UNITED STATES PATENT AND TRADEMARK OFFICE

APPLICATION NO.	FILING DATE	FIRST NAMED INVENTOR	ATTORNEY DOCKET NO.	CONFIRMATION NO.
10/759,840	01/17/2004	Harry C. Sweere	44374.12.3	8767

Office Action Summary	Application No. 10/759,840	Applicant(s) SWEERE ET AL.	
	Examiner Amy J. Sterling	Art Unit 3632

This is the first Office Action for application number 10/759,840 Support Arm, filed on 1/17/04. Claims 1-46 are pending. This application claims priority to provisional applications 60/441,143 dated 1/17/03, 60/471,869, dated 5/20/03, and 60/492,015 dated 8/1/03.

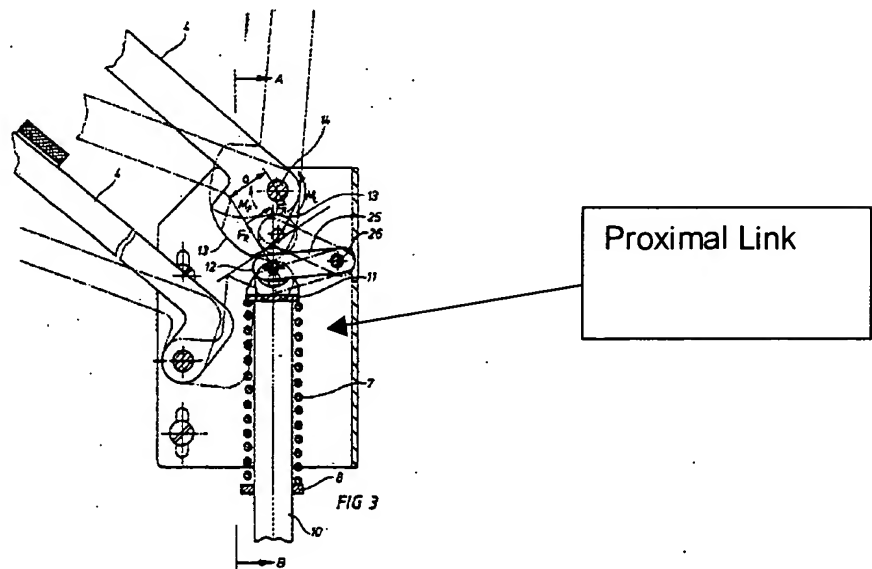
Claims 1-7, 10-19, 31-33, 37-44 and 46 are rejected under 35 U.S.C. 102(b) as being anticipated by United States Patent No. 5076533 to Schubert.

The patent to Schubert discloses a first strut (4) having a proximal portion pivotally coupled to a proximal link (See Drawing Below) at a first proximal joint (14) about a proximal pivot axis, a distal link (5) pivotally coupled to a distal portion of the first strut (4) at a first distal joint about a distal joint axis, a cam (13) with a substantially continually changing slot and substantially continually changing radius of curvature and is coupled to one of the links, a cam follower (12) being support by and contacting a cam surface of the cam at a first contact point, the cam and the cam follower cooperating to apply a cam moment to the first strut (See Col. 3, line 3-27) and the cam moment created by the reaction force between the cam and the cam follower is sufficient to balance a load supported by the distal link and a coil spring energy source (7) means for urging the cam follower against the cam surface, the strut moving up and down according to the compression or extension of the spring. Schubert also teaches an adjustment mechanism (8, 9, 27, 29) for varying a pre-load length characteristic of the spring, having a spring plate (9). Schubert teaches a second strut (4) having a proximal portion pivotally coupled to the proximal line at a second proximal joint and a

Schubert also teaches that the strut angle is defined by a longitudinal axis which extend through the first proximal pivotal joint and the first pivotal distal joint of the first strut and a direction of gravitational pull and wherein the cam moment varies as a function and in proportion to a SIN of the strut angle when the first strut rotates relative to the cam and wherein the contact angle is defined by a longitudinal axis of the first strut and a tangent line extending through a first contact point, and wherein the tangent line is tangent to the cam surface and tangent to a follower surface of the cam follower.
